Accessibility Survey

City of Downey Foster Road - Bellflower Boulevard to Hanwell Avenue

Date of Inspection
8/23/2017

Disability Access Consultants

Change in Level West of Ardis Avenue @ 33.909847290714, -118.132315725088

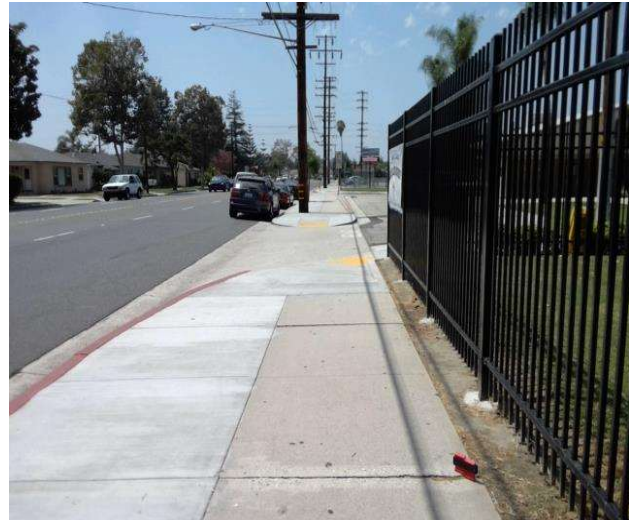
There is a change in elevation greater than recommended value.

On-Site Finding 0.50 inches

Ensure that the change in elevation is within the recommended value.

Recommendation Up to 0.25 inches

Change in Level West of Bluegrove Avenue @ 33.909131625723, -118.137685507536

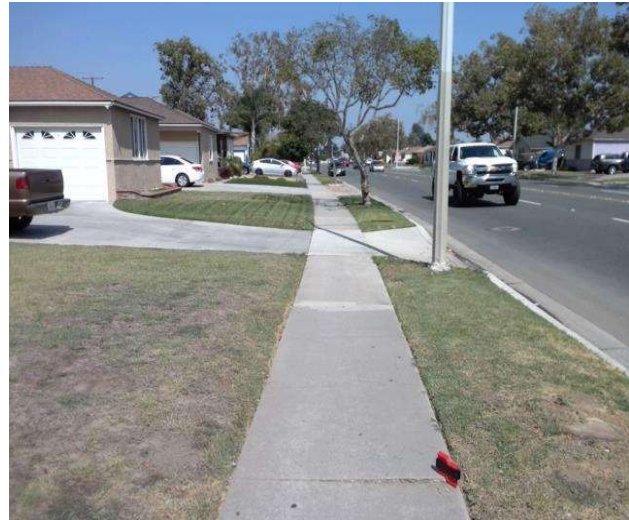
There is a change in elevation greater than recommended value.

On-Site Finding 1.00 inches

Ensure that the change in elevation is within the recommended value.

Recommendation Up to 0.25 inches

Change in Level West of Bluegrove Avenue @ 33.909148320931, -118.137602359056

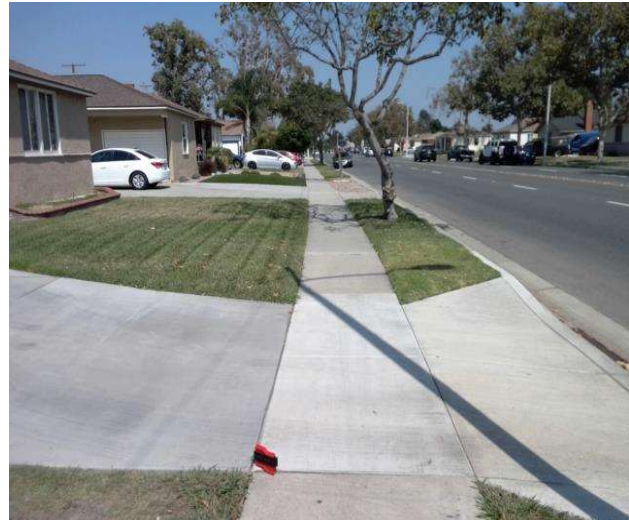
There is a change in elevation greater than recommended value.

On-Site Finding 0.62 inches

Ensure that the change in elevation is within the recommended value.

Recommendation Up to 0.25 inches

Change in Level West of Ardis Avenue @ 33.909857307755, -118.132412284613

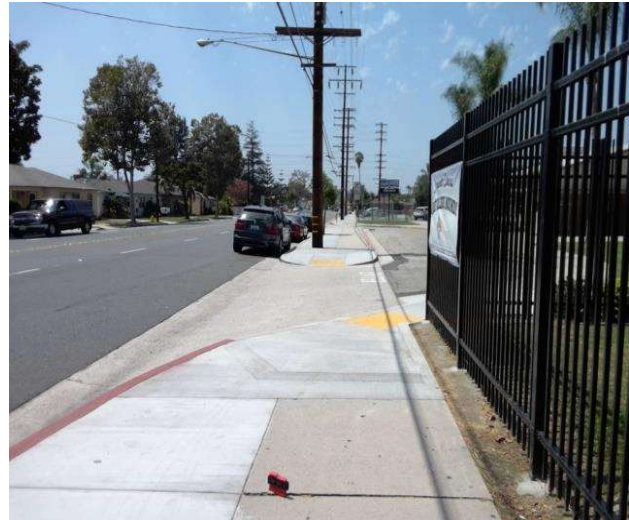
There is a change in elevation greater than recommended value.

On-Site Finding 0.37 inches

Ensure that the change in elevation is within the recommended value.

Recommendation Up to 0.25 inches

Driveway West of Ardis Avenue @ 33.909852855737, -118.132134675980

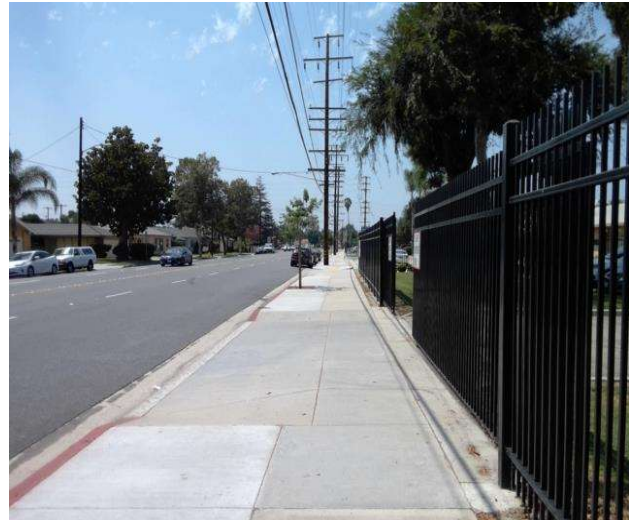
There are no detectable warnings where the pedestrian route crosses vehicular traffic.

On-Site Finding Not Found

Provide detectable warnings.

Driveway West of Ardis Avenue @ 33.909852855737, -118.132134675980

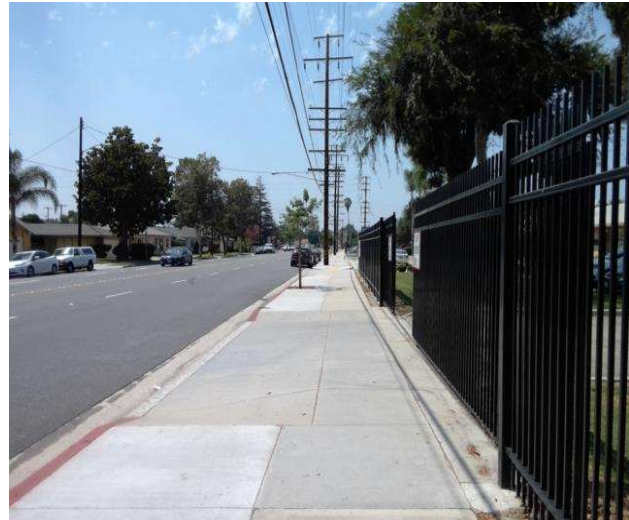
Cross slope at vehicular traffic is not compliant.

On-Site Finding 3.60 percent

Repave the surface to provide a compliant cross slope.

Recommendation Up to 2.08 percent

Sidewalk West of Ardis Avenue @ 33.909852855737, -118.133337646723

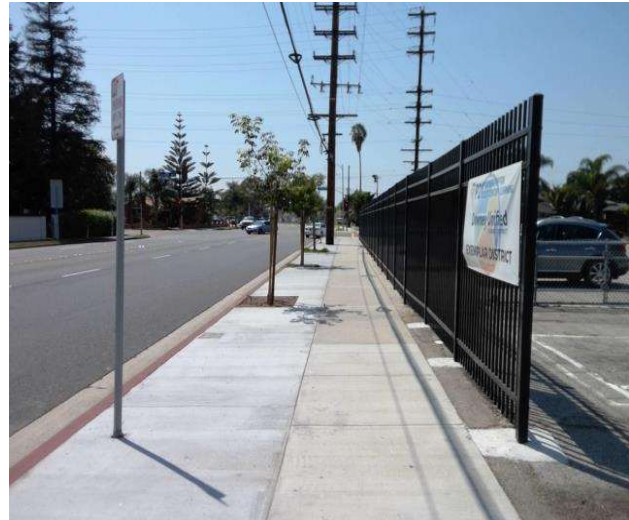
Sidewalk cross slope is not compliant.

On-Site Finding 3.20 percent for 173.00 feet

Repave the sidewalk surface with the recommended cross slope.

Recommendation Up to 2.08 percent

Sidewalk West of Ardis Avenue @ 33.909856194751, -118.131272345781

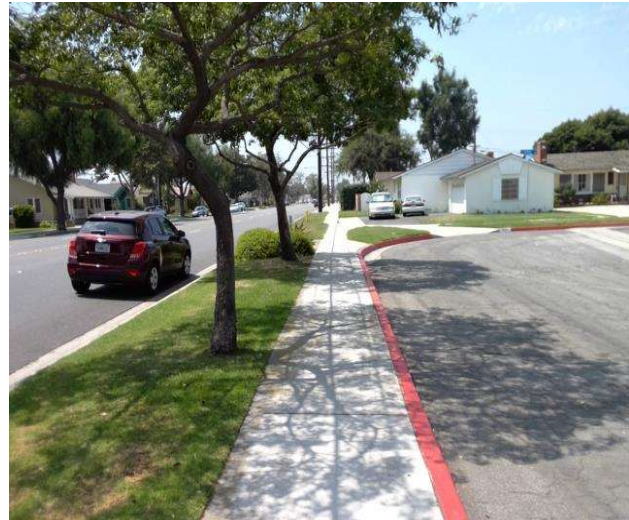
Sidewalk cross slope is not compliant.

On-Site Finding 4.00 percent for 74.00 feet

Repave the sidewalk surface with the recommended cross slope.

Recommendation Up to 2.08 percent

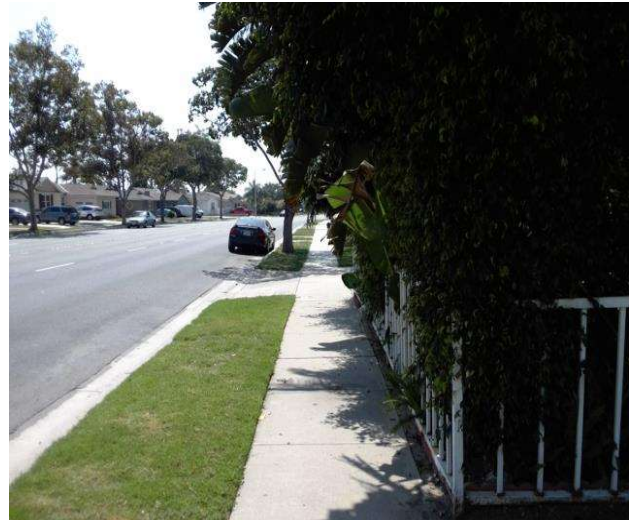
Overhead obstruction height is not compliant.

On-Site Finding 44.00 inches

Provide a compliant vertical clearance height.

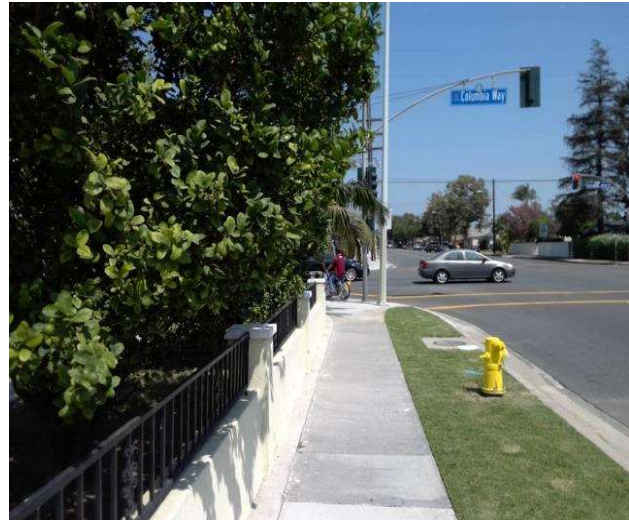
Overhead obstruction height is not compliant.

On-Site Finding 59.00 inches

Provide a compliant vertical clearance height.
